Service Letter

S.L. Number:	ZE-2009-02B (an improved substitute for ZE-2009-02A)
Date of issue:	November 28, 2009
Subject:	Alternative design for a fuselage-mounted aileron stop (a.k.a. “Torque Tube Stop”)
Affected Models:	All Zenair Zodiac CH 601 XL (factory-built ULM and kit-built models).
Serial Number(s)	All Affected Models
Manufactured by:	Czech Aircraft Works (CZAW) and others.
Purpose:	Most Zenair CH 601 XL built to the LTF-UL standards have a Czech-designed “Torque Tube Stop” mounted at the rear of the control stick (CZAW drwg. ref. 6-B-17CZ) to protect the aileron control system from mishandling or abuse. This Service Letter proposes a differently designed “stop” which allow for easier maintenance/adjustments of nearby control cables. In cases where the original CZAW part is not yet installed, Zenair recommends installation of the new design (drwg. 6Z-3G) in all affected aircraft.
Directed Action(s):	If a “Torque Tube Stop” is not yet installed in an affected aircraft, obtain this newly designed “aileron stop” (drwg. 6Z-3G) and install the parts using the information provided on the drawings (Page 2). If the CZAW-style stop is already in place, no further action is needed

6Z-3G-1 STANDARD L ANGLE
 $t=.025''$ 6061-T6 (1REQ'D)

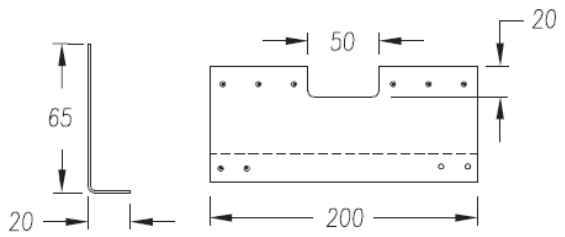
6Z-3G-1
 ADD AN L ANGLE TO SIDES OF REAR TORQUE TUBE BEARING SUPPORT 6B17-1
 A4 PITCH 30

6Z-3G-2 AILERON CONTROL STOP
 $t=.040''$ 6061-T6 (1 REQ'D)

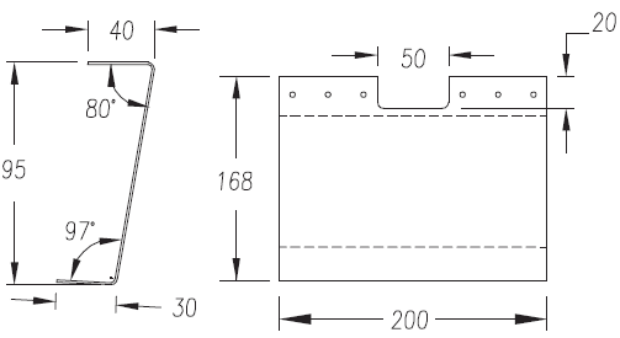
The following Torque Tube (aileron) stop was designed by Zenair to protect the control system from rough hangar handling, high winds when tied down outside, or from exceedingly heavy loads applied to the stick(s) by pilot or passenger when getting in and out of the aircraft. The advantage of this new design is that it allows easier access to nearby control cables and turnbuckles than the previous design proposed by CZAW. To comply with original LTF-UL certification documents, a Torque Tube Stop is mandatory for German-registered Zodiac aircraft (it is highly recommended for all others) and either design is acceptable (see ZE-2009-02A or ZE-2009-02B).
